AGENDA FOR THE CITY REVIEW COMMITTEE PUBLIC HEARING

PLRG25-00005 - Lot 5 and a portion of Lot 4, Block 5, Rim Road Addition, an addition to the City of El Paso, El Paso County, Texas.

PLANNING & INSPECTIONS DEPARTMENT CITY REVIEW COMMITTEE STAFF REPORT

Case No: PLRG25-00005
CRC Hearing Date: May 14, 2025
Case Manager: Jose Beltran, 915-212-1607, BeltranJV@elpasotexas.gov
Location: 925 Rim Rd.
Legal Description: Lot 5 and a portion of Lot 4, Block 5, Rim Road Addition, City of El Paso, El Paso County, Texas
Acreage: 0.39 acres
Zoning District: R-3/NCO (Residential/Neighborhood Conservancy Overlay)
Existing Use: Single-family residence
Project Description: Addition to existing single-family home and construction of a detached spa
Property Owner: Nancy and Ike Monty
Representative: Frederic Dalbin

Attachment 2: *Site Plan/Elevations/Renders*

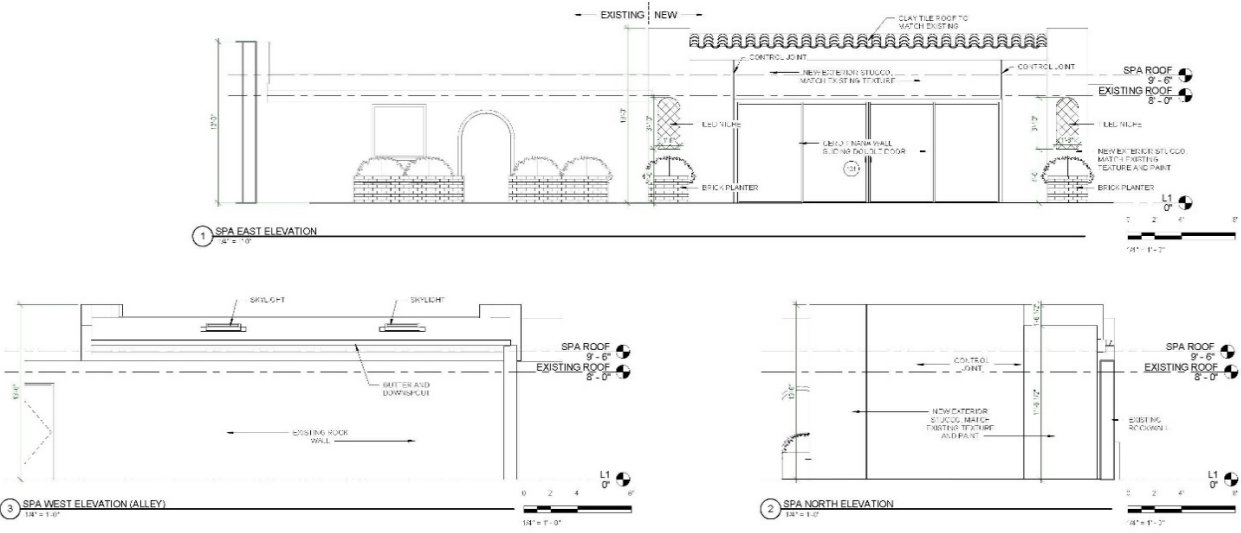
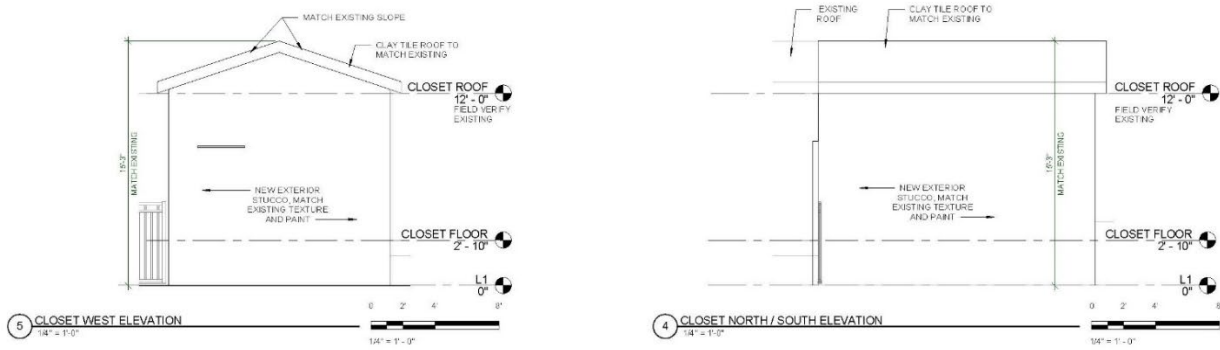
1. Building Setback and Site Development
 - (a) All excess soil resulting from site grading shall be removed from the property.
The applicant will be required to remove any excess soil from the property from site grading.
 - (b) Site layout, scale and mass of new construction shall be generally compatible with existing development in the same block.
The proposed development is compatible with the site layout, scale, and volumetric mass of the existing developments in the same block.

- (a) Additions to existing residences shall be constructed in the same architectural style as the existing residence.
The proposed addition will match the scale, materials and color of the existing residence.
- (b) Stucco construction shall present a smooth unbroken surface free from expansion joints except where necessary to prevent excessive cracking.
Expansion joints shall not be present unless necessary to prevent excessive cracking.
- (c) Trash containers, mechanical equipment and utility hardware on new construction shall be located at the rear of the lot or alley or screened from public view.
Trash containers, mechanical equipment and utility hardware will be screened from public view.

- (a) Mechanical equipment and utility hardware on new construction shall be screened from public view.
All proposed mechanical equipment and utility hardware on the property will be screened from public view.
- (b) The following roof forms may not be used on new construction: Mansard, Gambrel and Dome.
The proposed roof form is gable for the addition and flat for the detached spa.

Attachment 2: *Site Plan/Elevations/Renders*

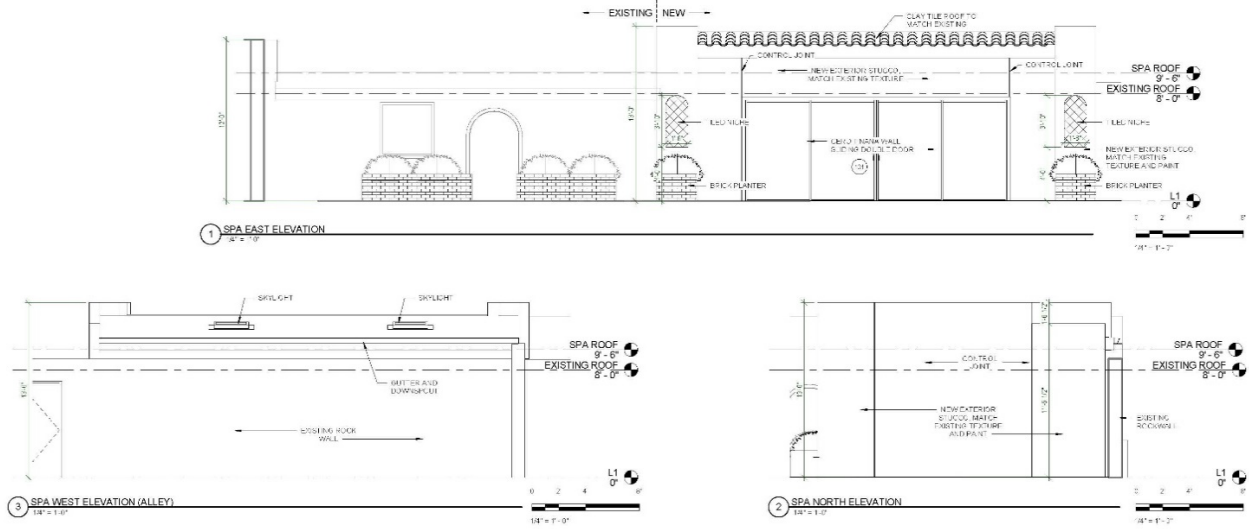
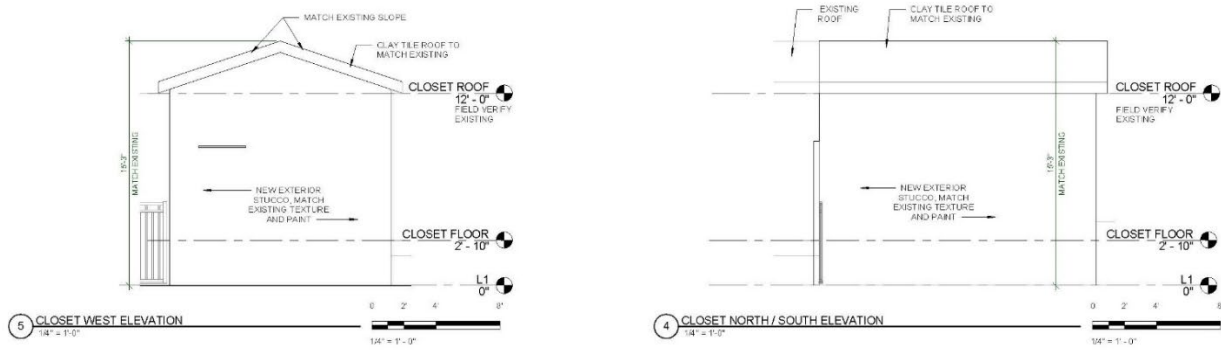
1. Building Setback and Site Development
 - (a) All excess soil resulting from site grading shall be removed from the property.
The applicant will be required to remove any excess soil from the property from site grading.
 - (b) Site layout, scale and mass of new construction shall be generally compatible with existing development in the same block.
The proposed development is compatible with the site layout, scale, and volumetric mass of the existing developments in the same block.

- (a) Additions to existing residences shall be constructed in the same architectural style as the existing residence.
The proposed addition will match the scale, materials and color of the existing residence.
- (b) Stucco construction shall present a smooth unbroken surface free from expansion joints except where necessary to prevent excessive cracking.
Expansion joints shall not be present unless necessary to prevent excessive cracking.
- (c) Trash containers, mechanical equipment and utility hardware on new construction shall be located at the rear of the lot or alley or screened from public view.
Trash containers, mechanical equipment and utility hardware will be screened from public view.

- (a) Mechanical equipment and utility hardware on new construction shall be screened from public view.
All proposed mechanical equipment and utility hardware on the property will be screened from public view.
- (b) The following roof forms may not be used on new construction: Mansard, Gambrel and Dome.
The proposed roof form is gable for the addition and flat for the detached spa.
